Access Compliance Report

(Curb Ramps)

Intersection ID: N/A	Main Street: STEEL_CREEK_RD	Cross Street: ENTRANCE_DR	Location: E
ADA ID: C6786286B8CD	Ramp Type: BlendTrans2	Initial Pass/Fail: Fail	Overall Compliance: No
Severity Score: 21.25			
Codes/Mitigation Info/Possible Solution		Field Measurements/Component Compliance

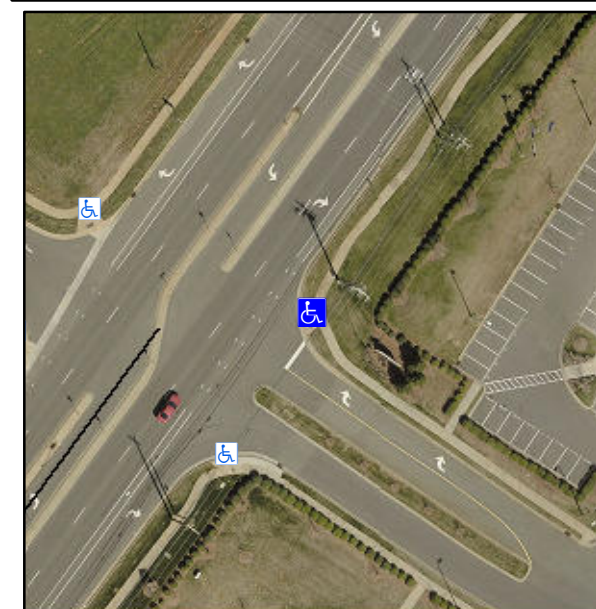
R304.5.1, R304.5.3

Compliance	Description	Data	Compliance	Description	Data
N/A	Ramp Length (in)	135.0	Yes	BlendTrans Slope (%)	3.9
No	Ramp Width (in)	47.0	No	BlendTrans XSlope (%)	6.1
N/A	Flare Type LT	N/A	N/A	Flare Type RT	N/A
N/A	Flare Slope LT (%)	N/A	N/A	Flare Slope RT (%)	N/A
N/A	Flare Traversable LT?	N/A	N/A	Flare Traversable RT?	N/A
N/A	Landing Length (in)	N/A	N/A	DWS Provided?	N/A
N/A	Landing Width (in)	N/A	N/A	DWS Contrast?	N/A
N/A	Landing Slope (%)	N/A	N/A	DWS Length (in)	N/A
N/A	Landing X Slope (%)	N/A	N/A	DWS Full Width?	N/A
N/A	Landing Curb? (Y/N)	N/A	N/A	DWS Offset (in)	N/A
N/A	Shared Landing?	N/A			
N/A	Gutter Ponding?	N/A	N/A	Gutter Slope (%)	N/A
N/A	Gutter Lip Ht (in)	N/A	N/A	Gutter X Slope (%)	N/A
N/A	Painted X Walk1?	No	N/A	Painted X Walk2?	No
	X Walk 1 Direction	To NW		X Walk 2 Direction	To SW
	X Walk 1 Width (in)	N/A		X Walk 2 Width (in)	N/A
	X Walk 1 Slope (%)	7.1		X Walk 2 Slope (%)	1.9
	X Walk 1 X Slope (%)	0.4		X Walk 2 X Slope (%)	4.7

Remove & Replace Curb Ramp With Two New Directional Ramps or Equivalent.
